Environmental Assessment

**Transfer of Land and Facilities within the East Tennessee
Technology Park and Surrounding Area,
Oak Ridge, Tennessee**

Date Issued—October 2011

**U. S. Department of Energy
Oak Ridge Office
Oak Ridge, Tennessee**

Fig. 3.3. The 100-year and 500-year floodplain and surveyed wetlands in the ETTP area.

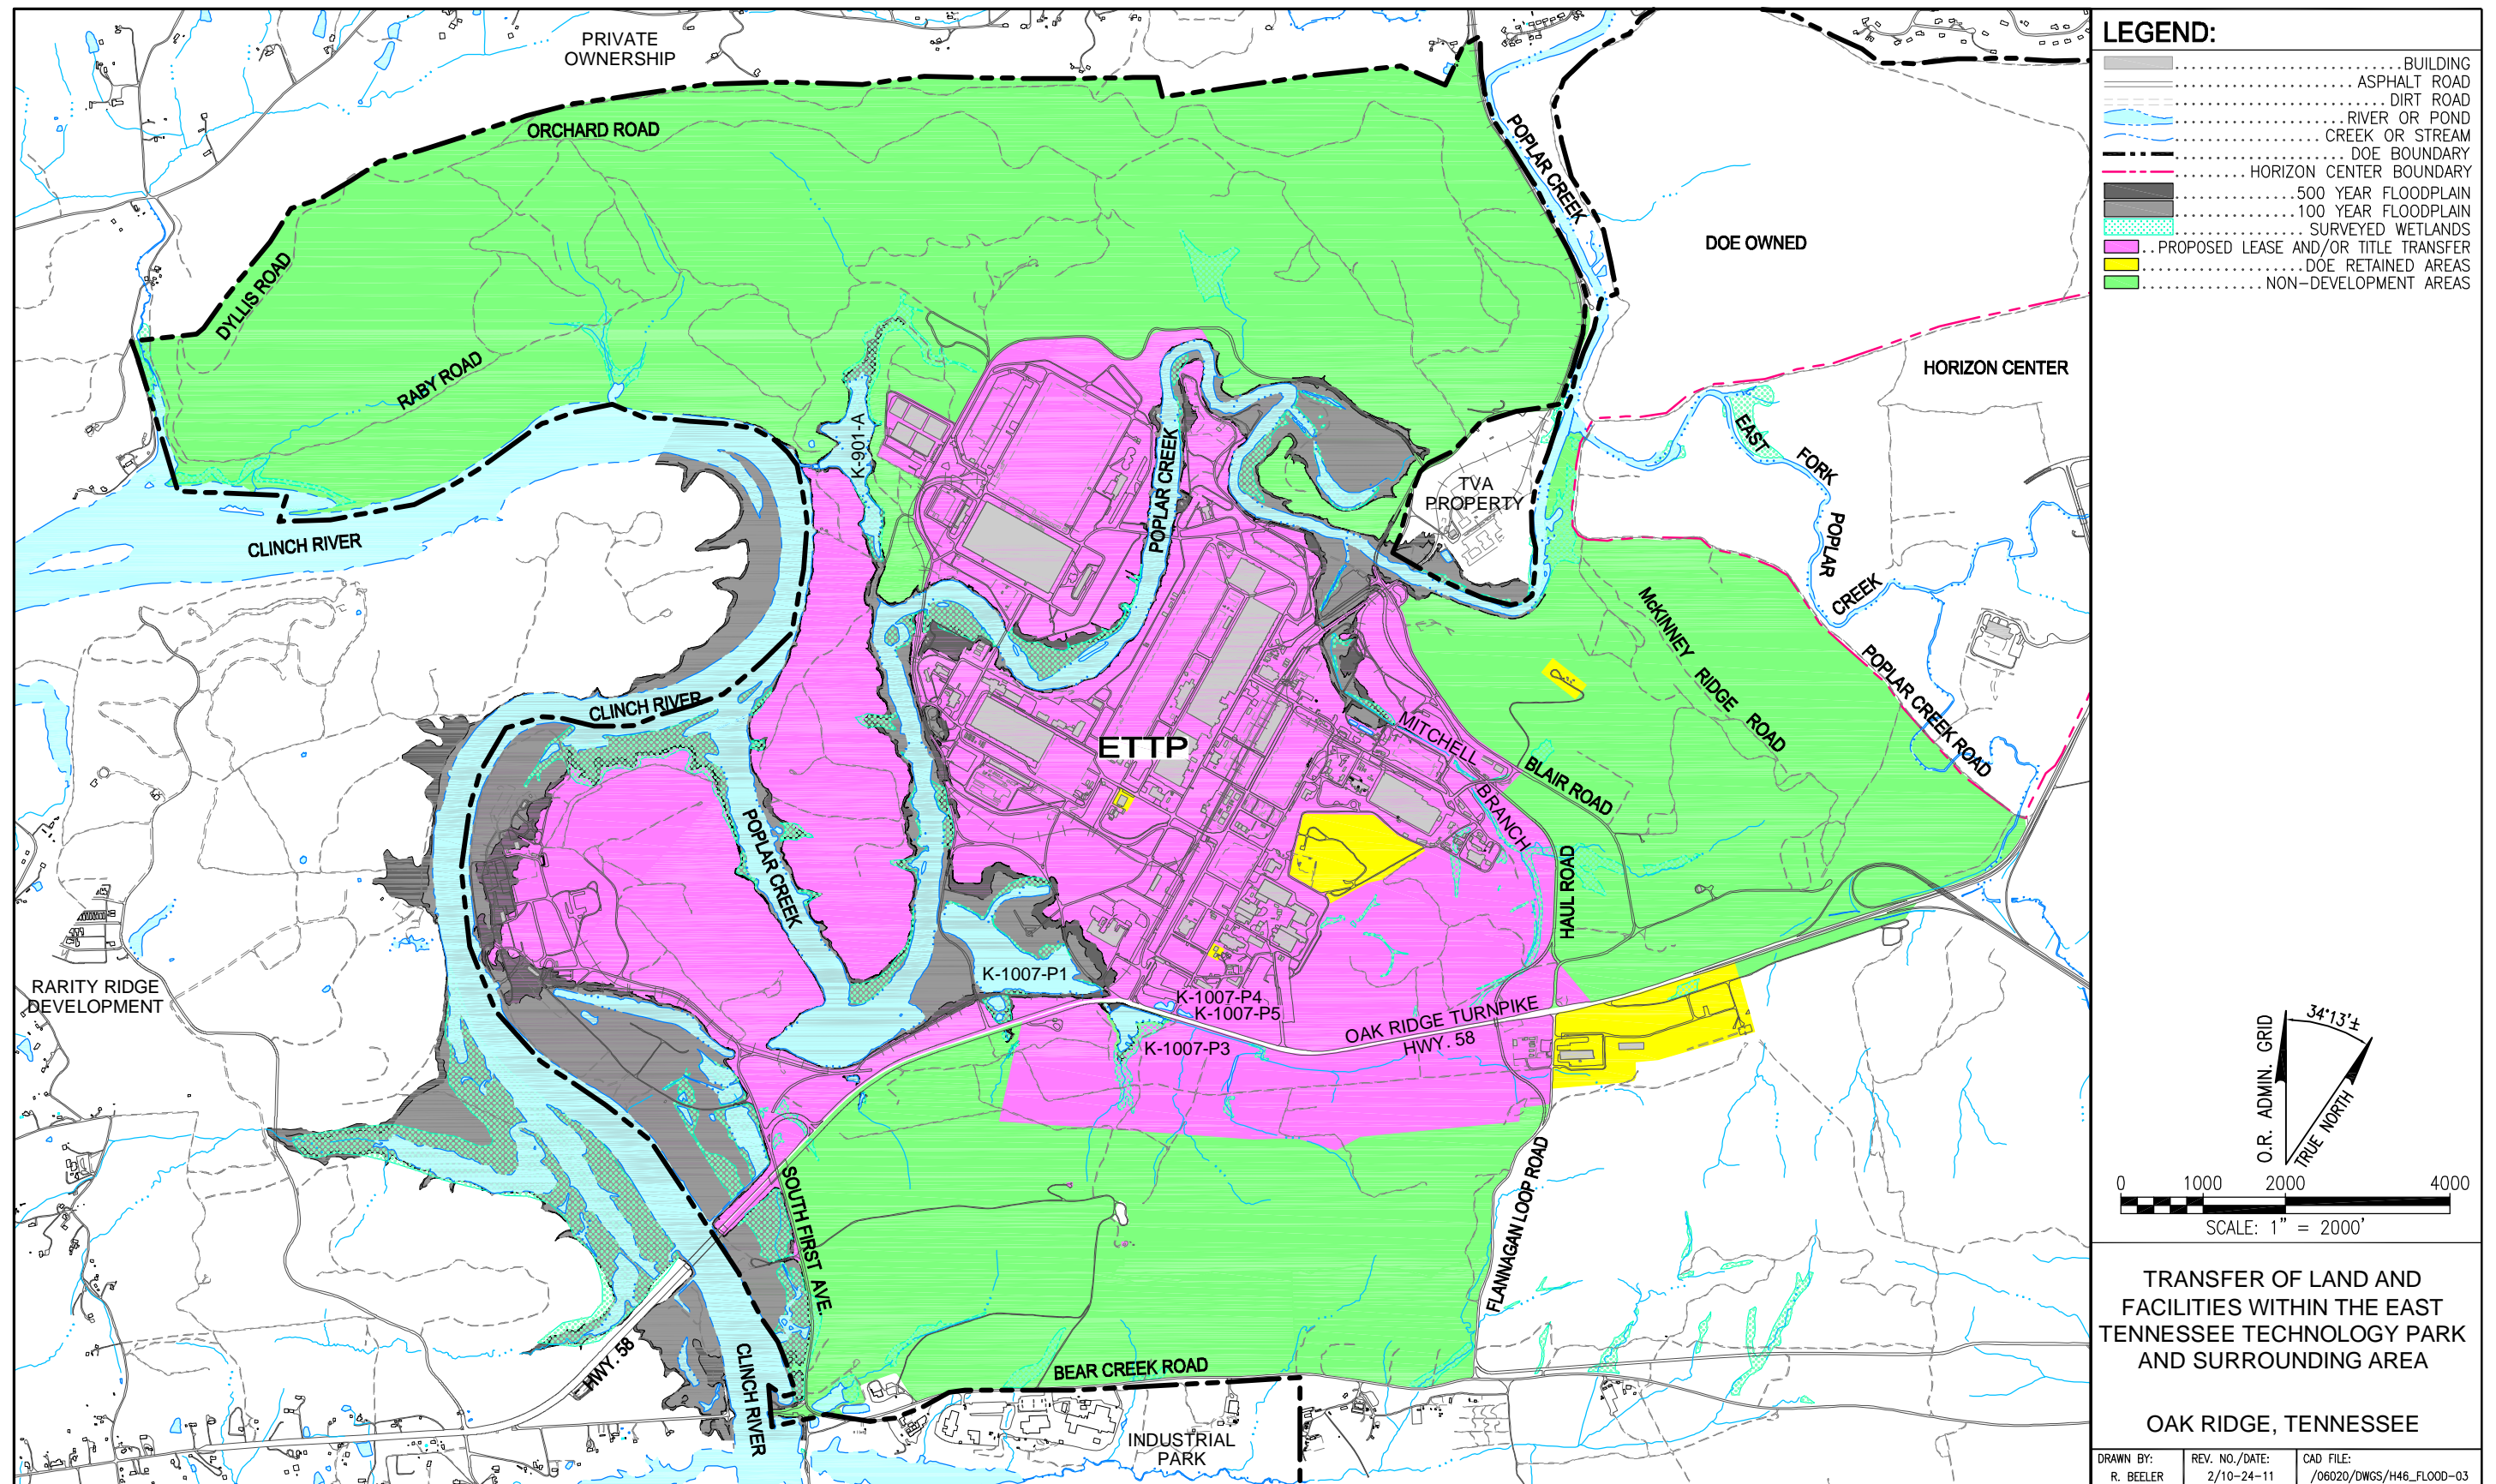
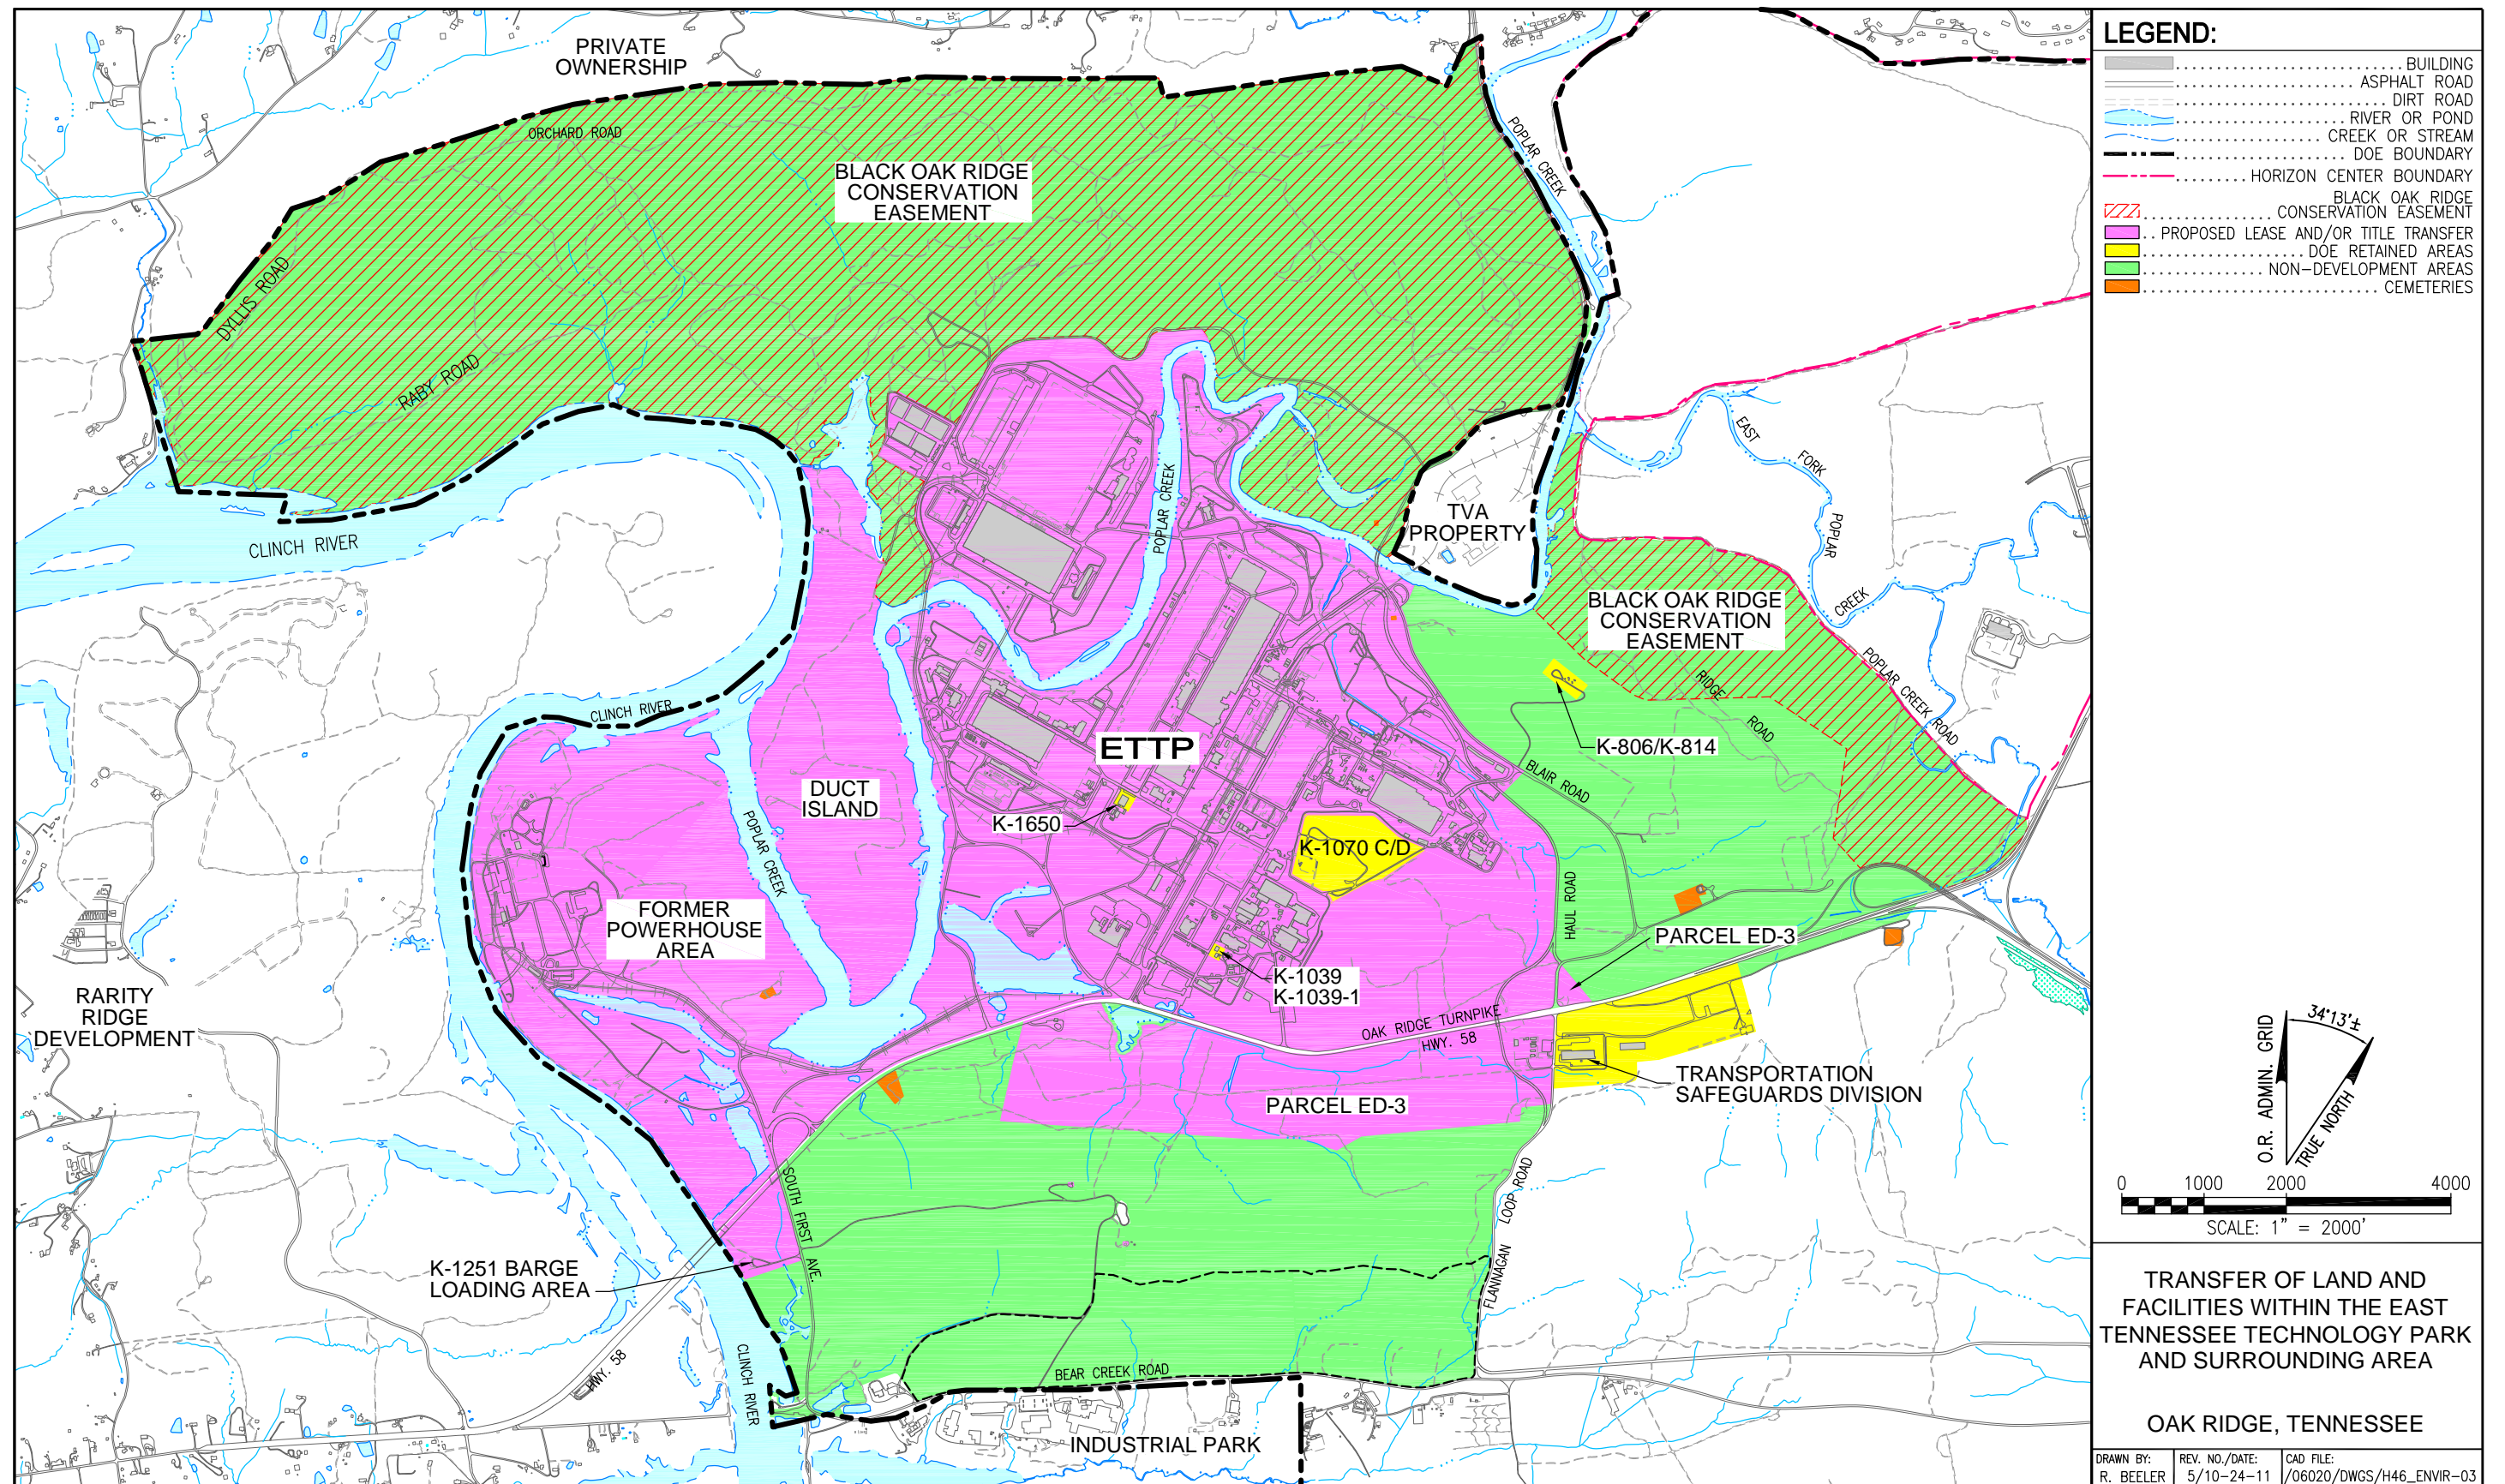
3			Figure 3.3 should be made consistent with Figure 1.1. In Figure 3.3, the property line between "DOE-OWNED" (labeled BLACK OAK RIDGE CONSERVATION EASEMENT on Figure 1.1) and Horizon Center is missing.	The Horizon Center boundary has been added to Fig. 3.3 for consistency.
4	Section 3.4.2.1		There are likely more potential impacts on the groundwater than stated in Section 3.4.2.1. The ubiquitous presence of karst provides an immediate conduit to subsurface drainages. Typically petroleum-contaminated runoff from paved areas (roads, parking lots) and accidental discharges of pollutants on to the ground can quickly find their way into the groundwater.	A statement has been added in Sect. 3.4 noting that the presence of karst has the potential to provide rapid transport pathways to groundwater resources beneath the ETPP.
